PROJECT
Monaghan, Community Peace Campus
Lands between North Road, Plantation Road and Glaslough Street, Kilnacloy, Monaghan Co. Monaghan

DRAWING
Proposed Cafe Servery Details

DRAWING NUMBER	REVISION	SCALE	DATE	DRAWN	CHECKED
3316-HBD-DT(7-)002	####	1:20, 1:10	03/10/2023	JS

1 Cafe Servery1.18 1:20

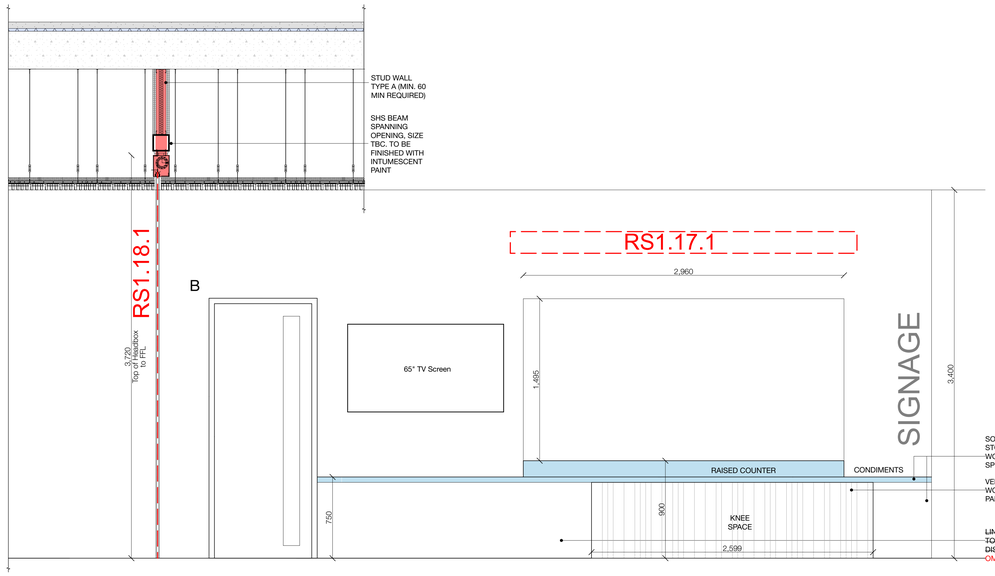
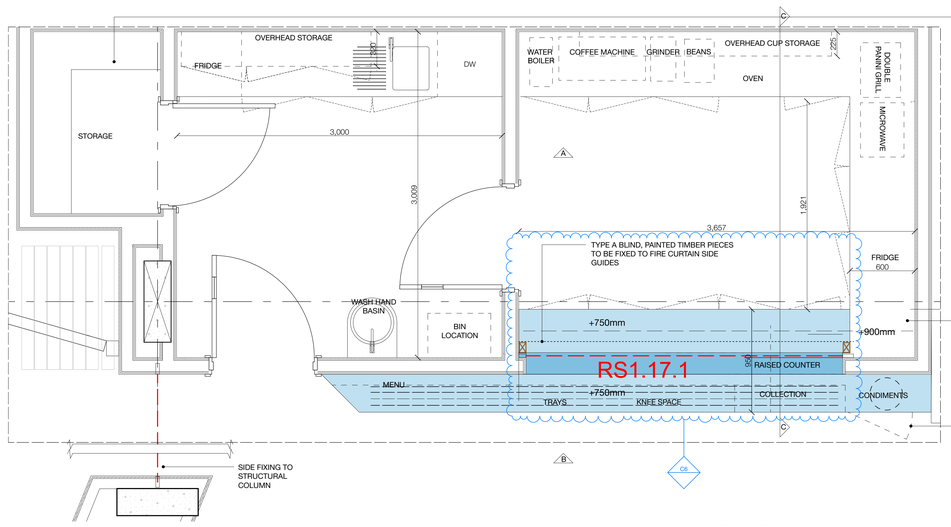
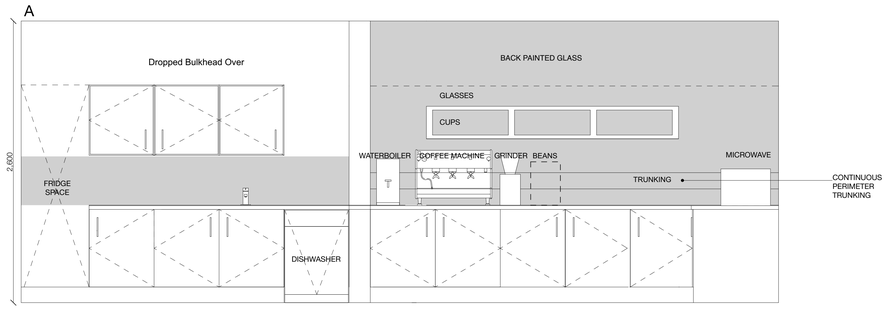
~~LINEAR VENT TO CHILLED DISPLAY.~~ OMITTED

~~HORIZONTAL SLIDING SCREEN REF:45-25-10 /320 TO BE LOCKABLE FULLY OPEN OR FULLY CLOSED. SIZED TO SUIT OPENING.~~ OMITTED

NO.	AMENDMENT	DATE	BY	CHECKED
C6	- Steel plate indicated to counter at Fire Curtain drop. - Type A blind (to replace sliding screen) indicated.	03.10.2023	KM	JS
C5	5.1 Worktop shortened and units moved to accommodate tall fridge. 5.2 Servery Fridge location shown and confirmed as integrated. 5.3 TV location shown	21.09.2022	KM	JS
C4	4.1 Additional Steel beam and stud wall above Fire Curtain RS 1.18.1 4.2 Section amended to suit Wall Type Tech submittal size. Max. support drop indicated to Fire Curtain RS 1.18.1 4.3 Section amended to suit Wall Type Tech submittal size	21.09.2022	KM	JS
C3	Servery door drawer to suit specification Wall arrangement amended to suit sliding partition	01.06.2022	KM	JS
C2	2.1 Detail revised	10.03.2020	MS	JS
C1	CONSTRUCTION ISSUE	27.07.2020	MS	JS
